ND-2012-0039  
July 19, 2012

Subject: **PSEG Early Site Permit Application**  
**Docket No. 52-043**  
**Response to Request for Additional Information, RAI No. 43, Vibratory Ground Motion**

**RESPONSE to RAI No. 43**

**QUESTION No.  
02.05.02-5**

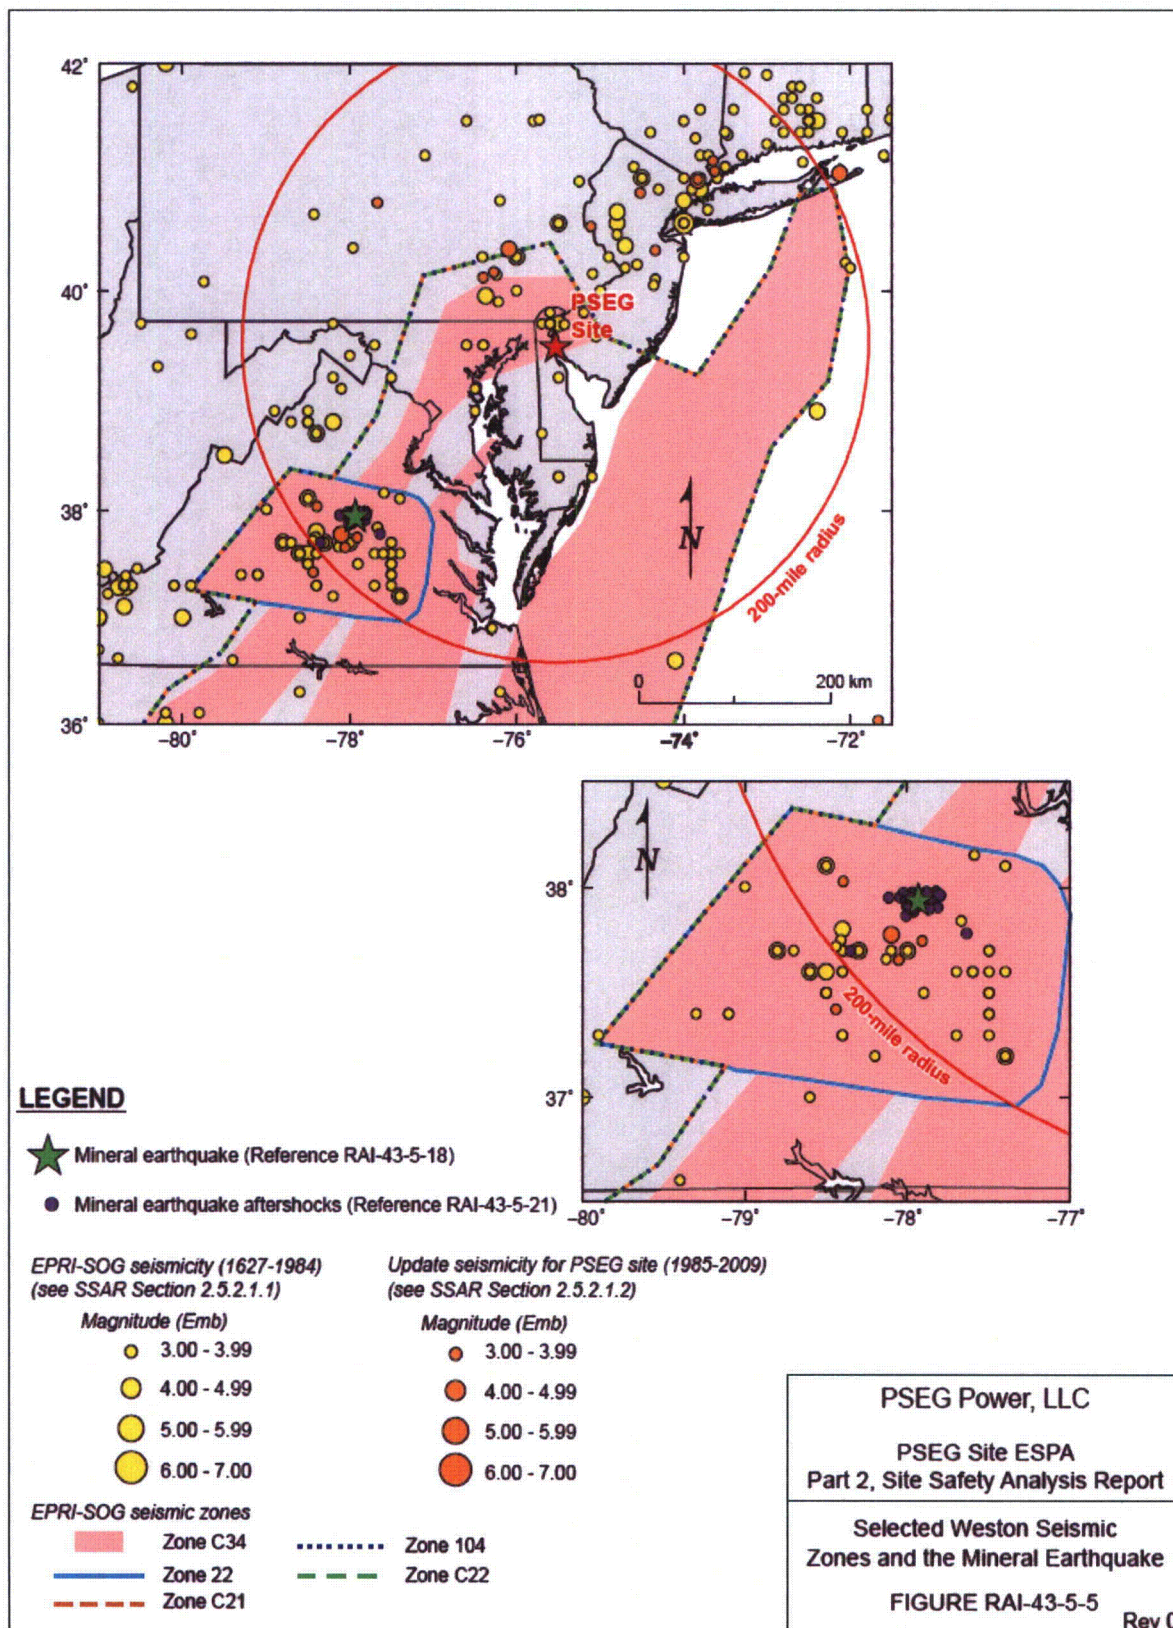
The Mineral earthquake occurred within two primary zones defined by the Weston team (Zones 22 and 104) and a series of combination zones that incorporate Zone 104 (Table RAI-43-5-3; Figure RAI-43-5-5).

For Zone 22, the updated Mmax distribution can be determined by truncating the original PDF for Zone 22 (Reference RAI-43-5-10, Vol. 5, C-65) at mb 6.0. This truncation magnitude ensures that the lower bound of the revised Mmax distribution is greater than the magnitude of the Mineral earthquake (mb 5.9). The resultant updated Mmax distribution for Zone 22 is then: 6.0 (0.81), 6.6 (0.19) (Table RAI-43-5-1).

The occurrence of the Mineral earthquake requires updating the Pa evaluation for Zone 22 because the largest observed earthquake in the zone prior to the Mineral earthquake was less than 5.0 (Emb 4.9 in 1833). Therefore, the weight that the zone is associated with earthquakes of magnitudes greater than or equal to mb 5.0 needs to be increased from the original value of 0.5. Because the Weston team's methodology does not provide enough information to determine how the occurrence of the Mineral earthquake would impact the evaluation of association with seismicity, the association with moderate to large earthquakes is increased to 1.0 and a decrease in the association with small earthquakes and no seismicity to 0 is made as a conservative approach. Applying these changes results in an updated Pa value for Zone 22 of 0.91 (Table RAI-43-5-1).

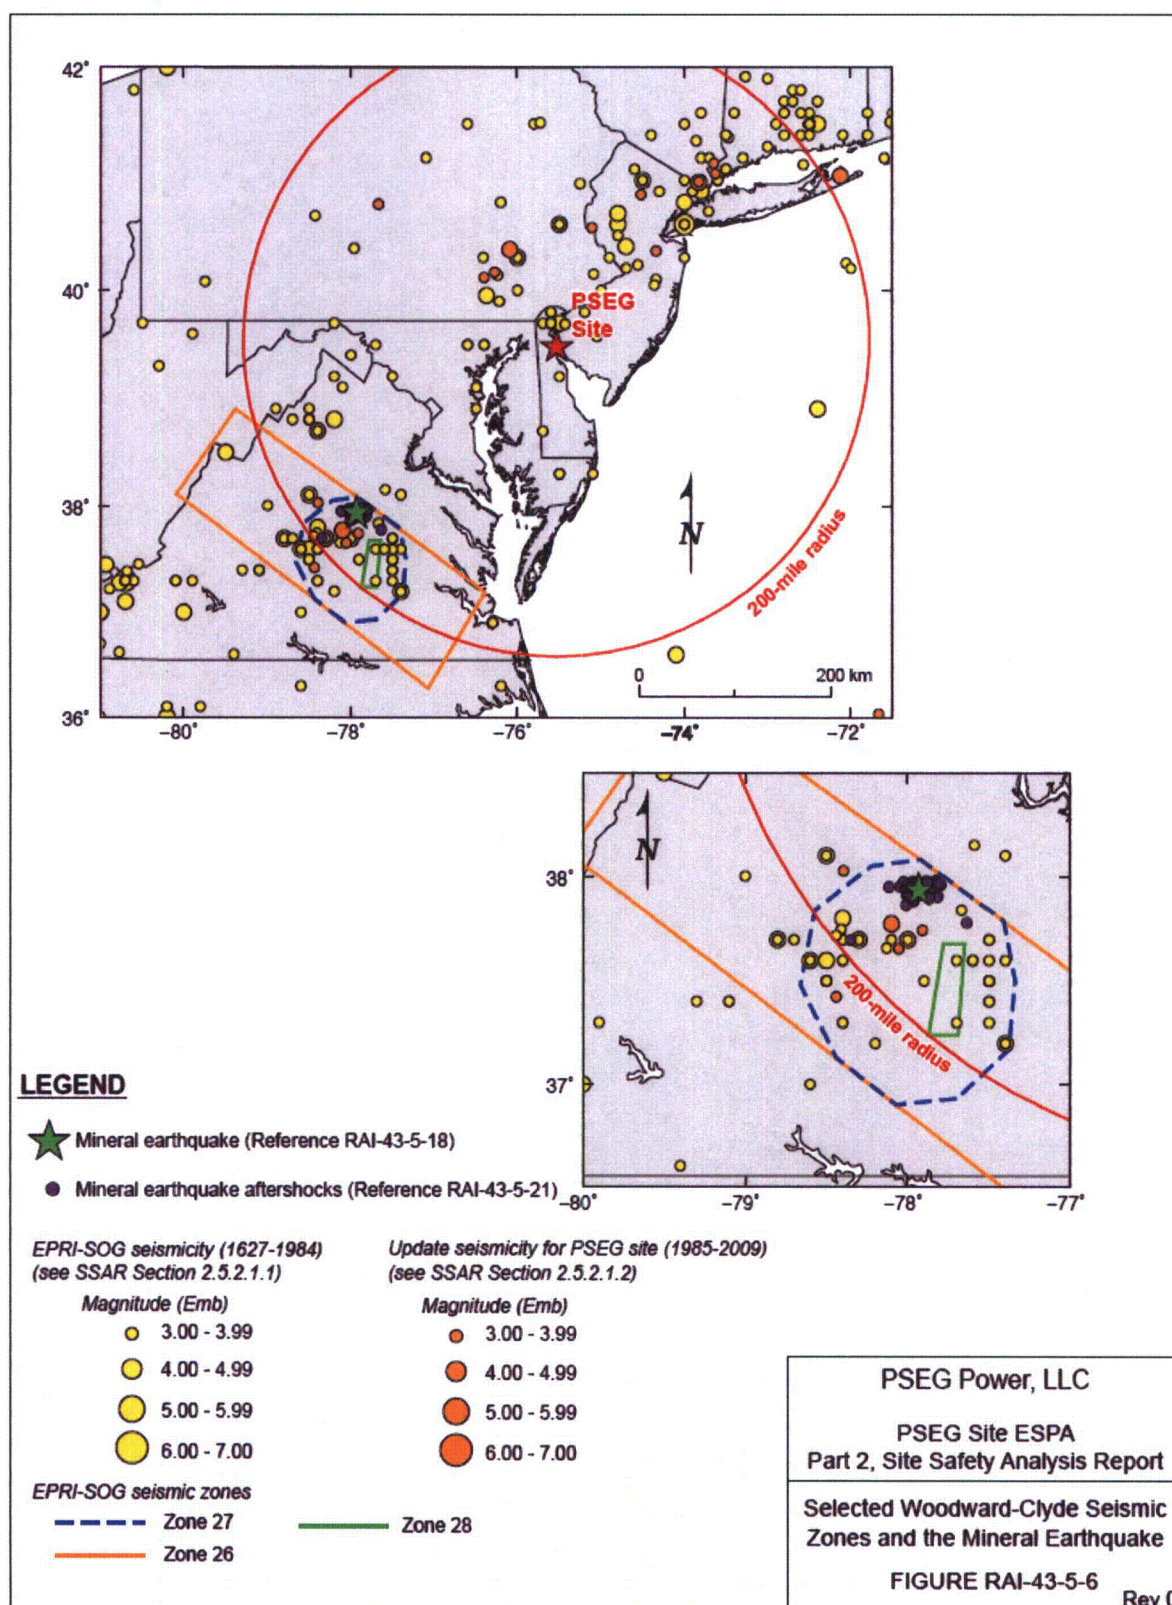
The Mineral earthquake occurs within two zones defined by the Woodward-Clyde team: Zones 26 and 27 (Table RAI-43-5-1; Figure RAI-43-5-6). Zone 28 does not contain the Mineral earthquake but is mutually exclusive with both Zones 26 and 27. Because the lower-bound Mmax values of both Zones 26 and 27 (mb 5.4 and mb 5.6, respectively) (Table 1) are less than the magnitude of the Mineral earthquake (mb 5.9) the Mmax distributions for both zones need to be updated.

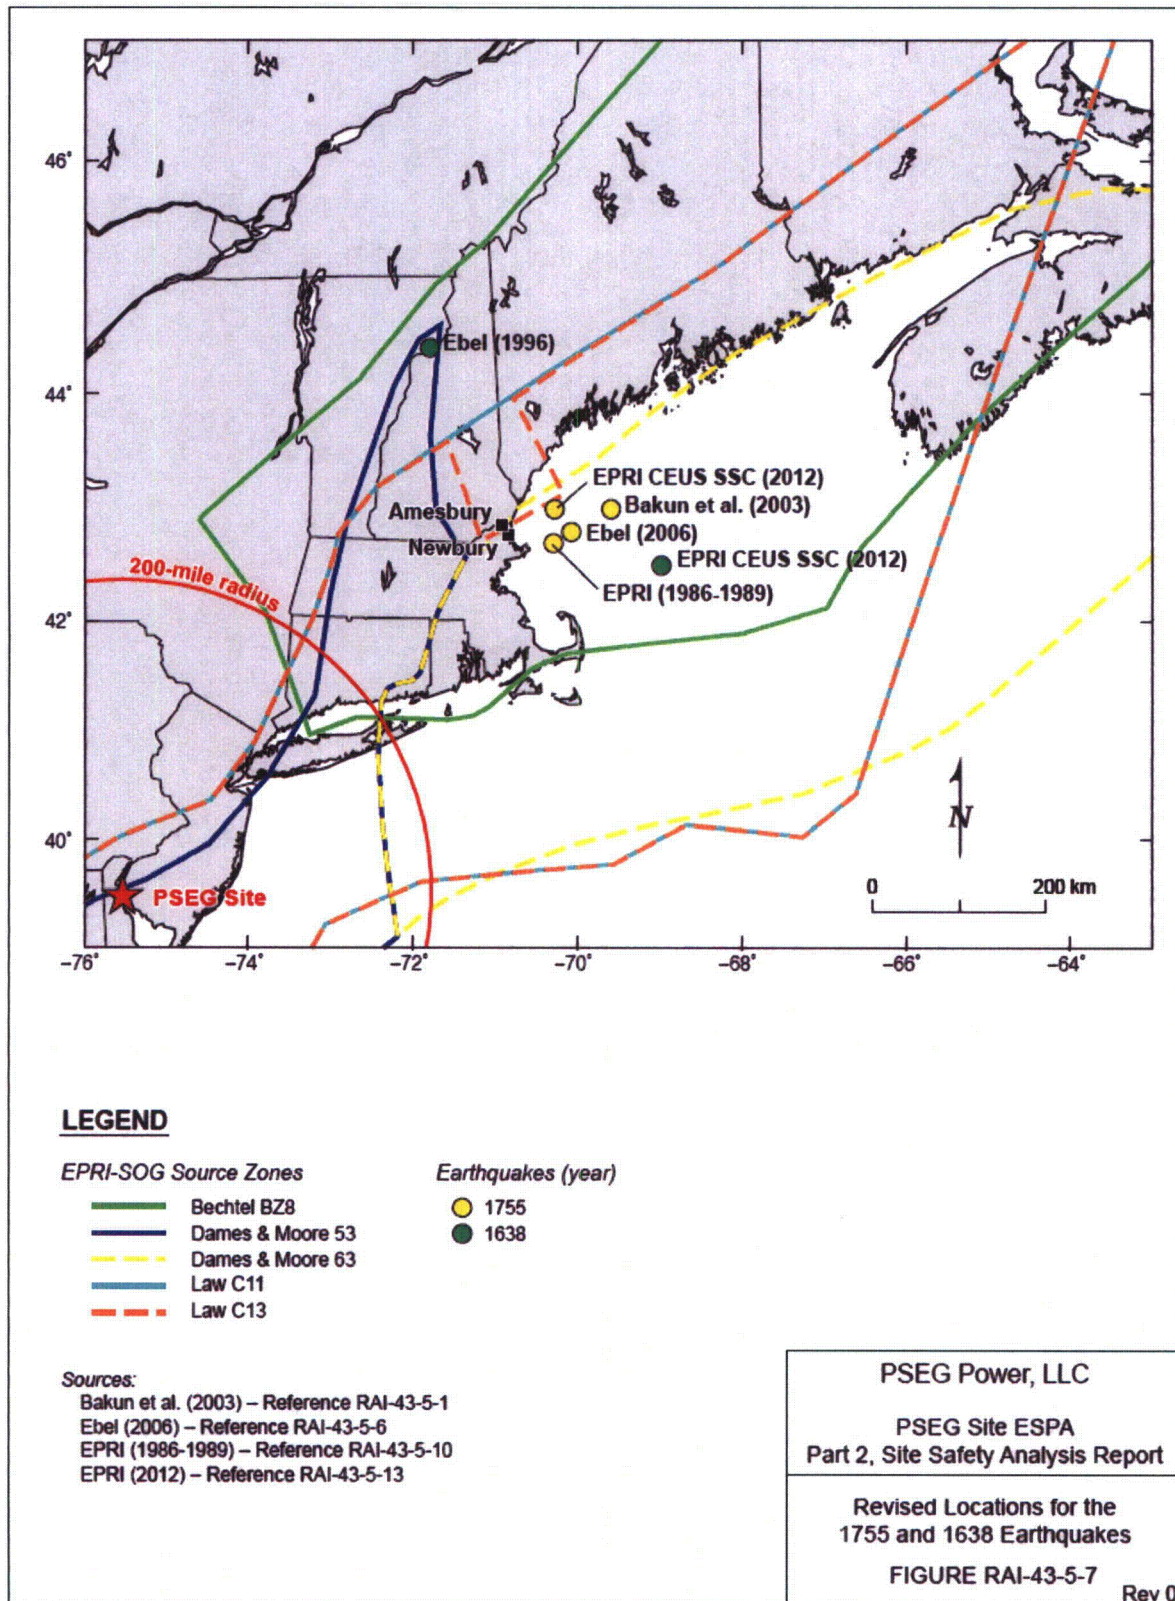
The response to RAI 43, Question 02.05.02-4b (Reference RAI-43-5-20), identifies specific seismic zones for three of the EPRI-SOG teams as potentially needing to be updated to adequately characterize more recent data and information regarding seismicity within the New England region. The bases for these updates are two earthquakes: the 11 June 1638 earthquake in central New Hampshire, and the 18 November 1755 Cape Ann earthquake off the coast of Massachusetts. The 1638 earthquake was not identified within the EPRI-SOG catalog, but Ebel (Reference RAI-43-5-5) describes the earthquake as having a magnitude of  $M_{Lg} 6.5 \pm 0.5$  (mb  $6.5 \pm 0.5$ ). Instead of adopting the magnitude of Ebel (Reference RAI-43-5-5) for the 1638 earthquake, the  $M_w 5.3$  (mb 5.7) magnitude of the earthquake as presented within the EPRI Central and Eastern United States Seismic Source Characterization (CEUS SSC) project seismicity catalog (Reference RAI-43-5-13) is adopted. This magnitude is preferred over the magnitude of Ebel (Reference RAI-43-5-5) because it was developed as part of the SSHAC Level 3 (Reference RAI-43-5-2) EPRI CEUS SSC project, as opposed to the magnitude of Reference RAI-43-5-5 that represents the opinion of a single researcher. Similarly, the 1755 earthquake is given a magnitude of  $M_w 6.1$  (mb 6.3) in the EPRI CEUS SSC catalog (Reference RAI-43-5-13). This magnitude is adopted over those presented by Reference RAI-43-5-6 and Reference RAI-43-5-1. The locations of these earthquakes as presented within the EPRI CEUS SSC project (Figure RAI-43-5-7) are also adopted.

FIGURE RAI-43-5-8

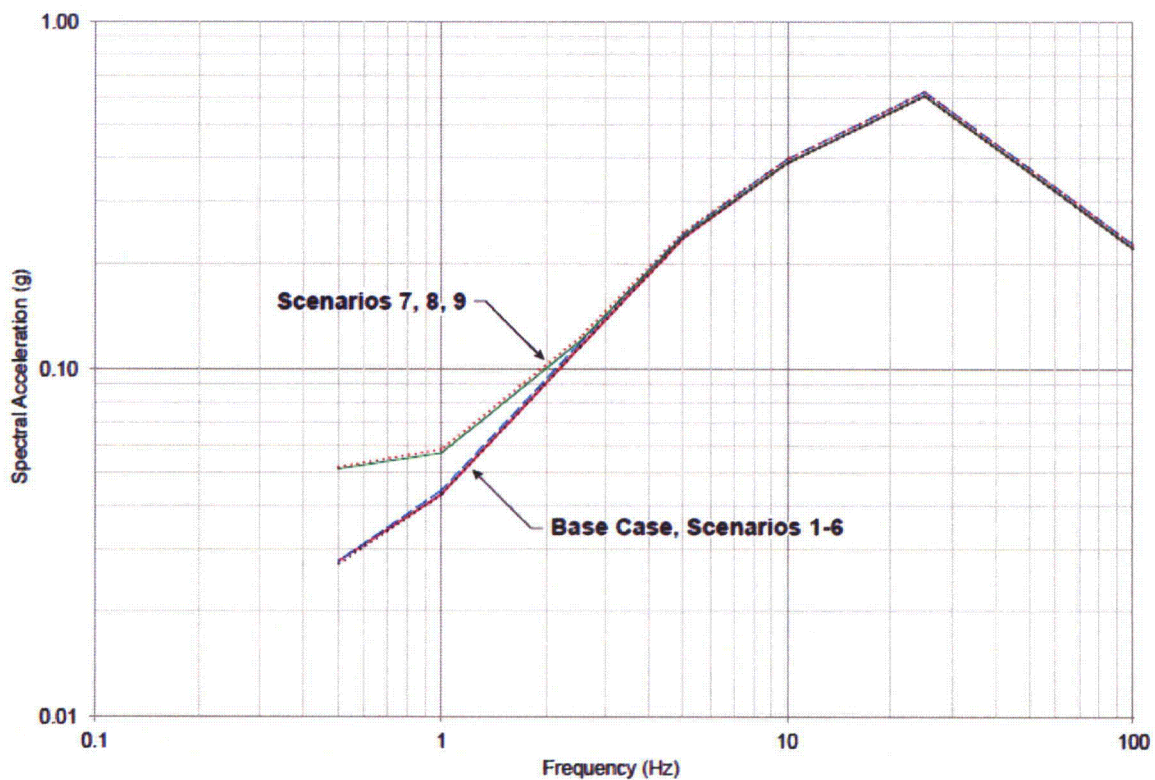
Table RAI-43-5-4, Table RAI-43-5-5, and Figure RAI-43-5-8 demonstrate that:

Table RAI-43-5-4, Table RAI-43-5-5, and Figure RAI-43-5-8 illustrate the impact of the updated catalog extent scenario (Scenario 3), as well as the other scenarios presented in Table RAI-43-5-2 and show that there is no impact on the PSEG Site rock GMRS from taking into account the impact of the updated catalog extent on the EPRI-SOG source model used for the PSEG Site.

Table RAI-43-5-4, Table RAI-43-5-5, and Figure RAI-43-5-8 demonstrate that accounting for new information with respect to New England earthquakes has a very small impact only at low frequencies (e.g., largest increase over PSEG SSAR rock GMRS of 0.1% at 1.0 and 0.5 Hz)

Table RAI-43-5-4, Table RAI-43-5-5, and Figure RAI-43-5-8 demonstrate that:
